Subject: U. S. Fuel Company's Revision to MRP at the Hiawatha
 Complex for New Coal Loadout and Preparation Facility.

The Division has evaluated U. S. Fuel Company's proposal to revise the Mining and Reclamation Plan at the Hiawatha Complex to include a new coal loadout and coal processing facility.

On October 25, 1984, a meeting was held in your office to discuss the remaining issues pertaining to the permit application package (PAP) for U. S. Fuel's Hiawatha Mine. The Office of Surface Mining (OSM) is preparing its recommended decision. Those issues that remain unresolved may result in a partial approval or complete disapproval of the permit application. It is incumbent upon the applicant to promptly provide the necessary information that demonstrates compliance with the Utah Regulatory Program. The deficient sections were discussed at the meeting and are reiterated below.

TECHNICAL ANALYSIS

**Figure 9
 HIAWATHA MINES COMPLEX
 EXISTING SEDIMENTATION PONDS**

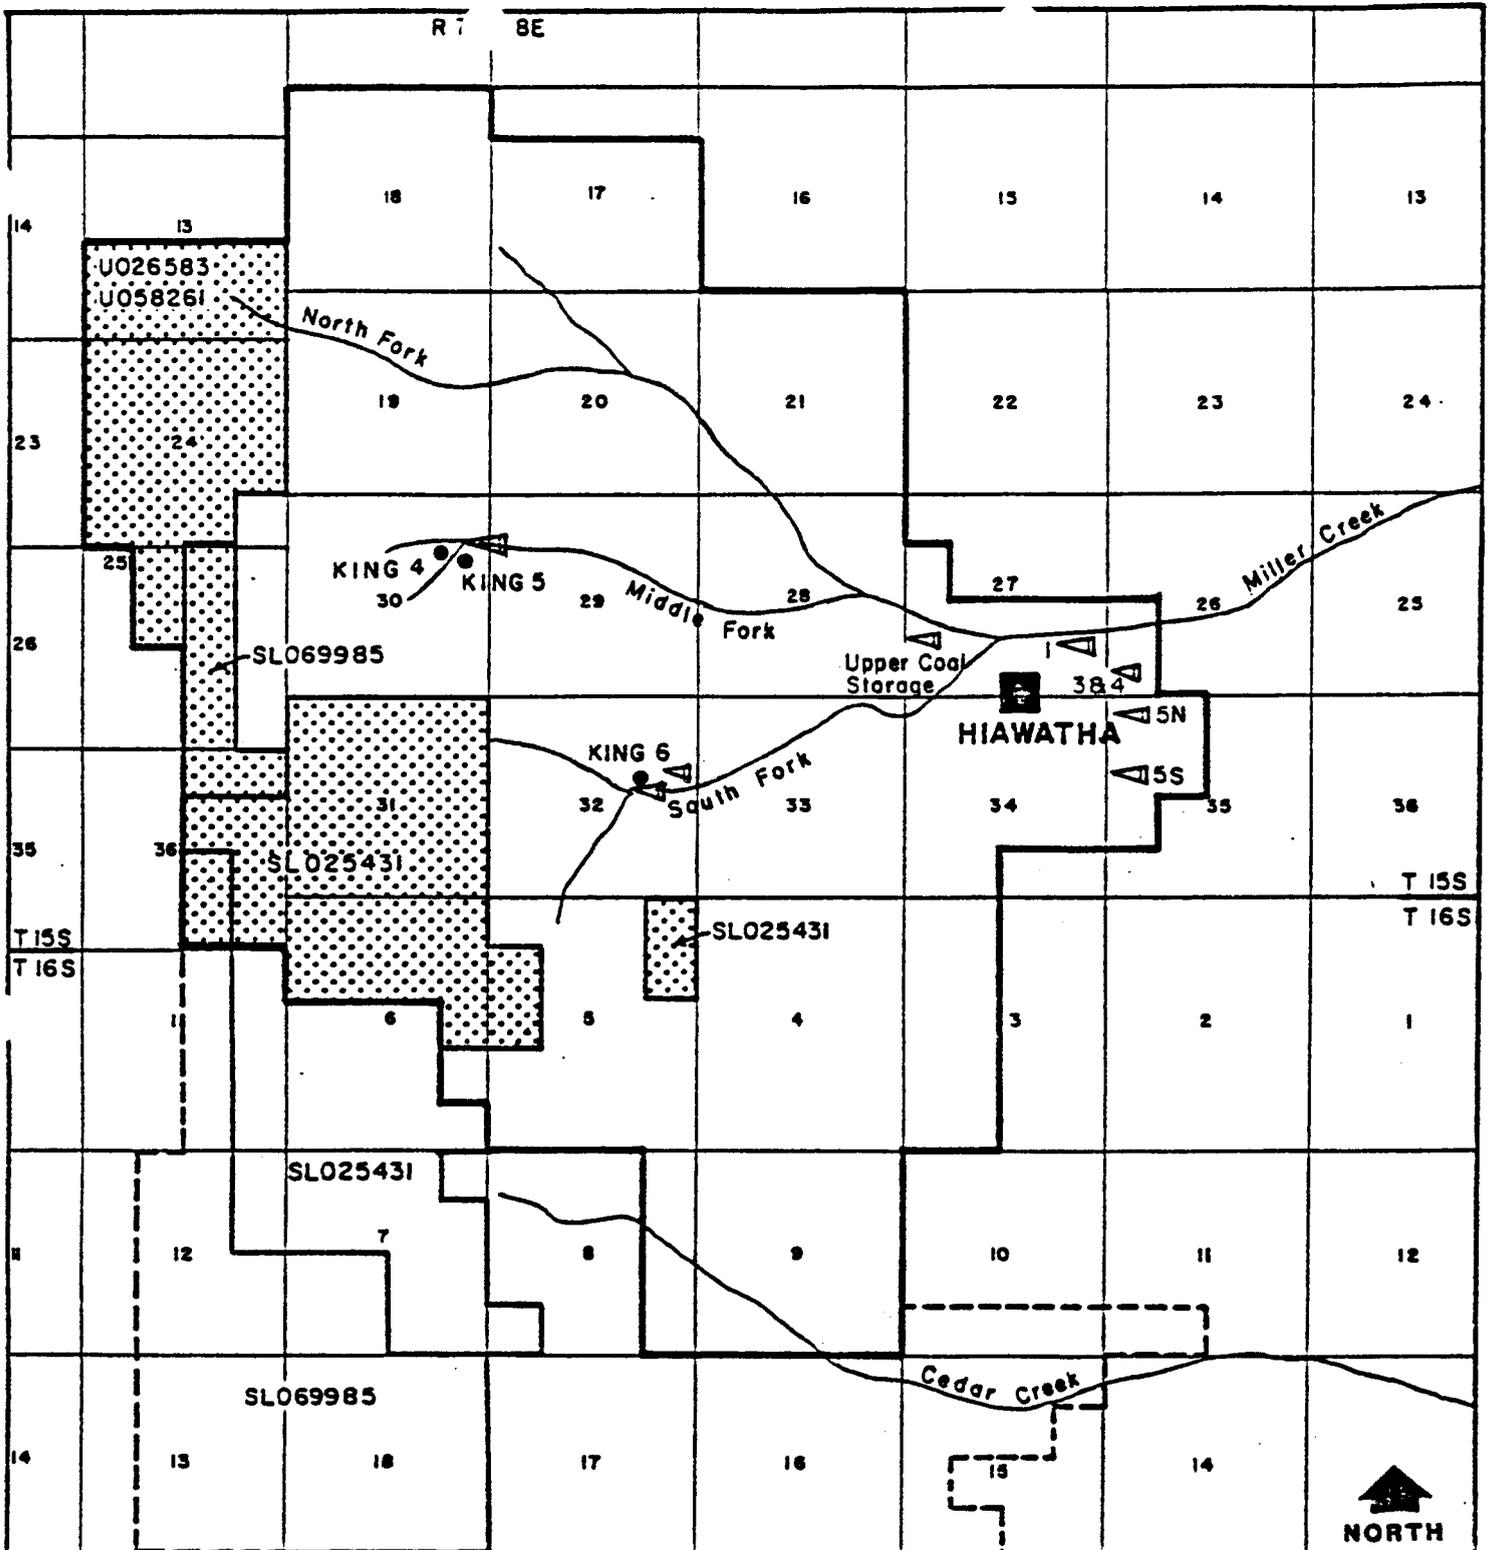
The Hiawatha Mines Complex currently contains eight sedimentation ponds (see Figure 9). Most of these ponds were constructed in 1978 or 1979 to achieve on-the-ground compliance with the drainage and sediment control rules and regulations of OSM's interim regulatory program. Approval of the sedimentation ponds for the Middle Fork portal yard, South Fork portal yard, and upper coal storage yard was given by OSM and UDOGM on 30 May 1980. Approval of the ponds was given by Utah Water Pollution Control in August 1979. The sediment control structures for the coal pile/truck loadout area on the South Fork were reviewed by OSM and UDOGM during the analysis in conjunction with the reopening of King No. 6 Mine (approved 15 July 1981). Review and approval of the other sedimentation ponds were deferred for later review.

The applicant has constructed a small (about 1 acre) ventilation pad on the Right Fork of the North Fork of Miller Creek (see Figure 9). Because of the small area of disturbance, a small area exemption was allowed (UMC 817.42 (a)(3)), and the applicant is using strawbales to control sediment from the area. This is in compliance with UMC 817.42 and 817.45.
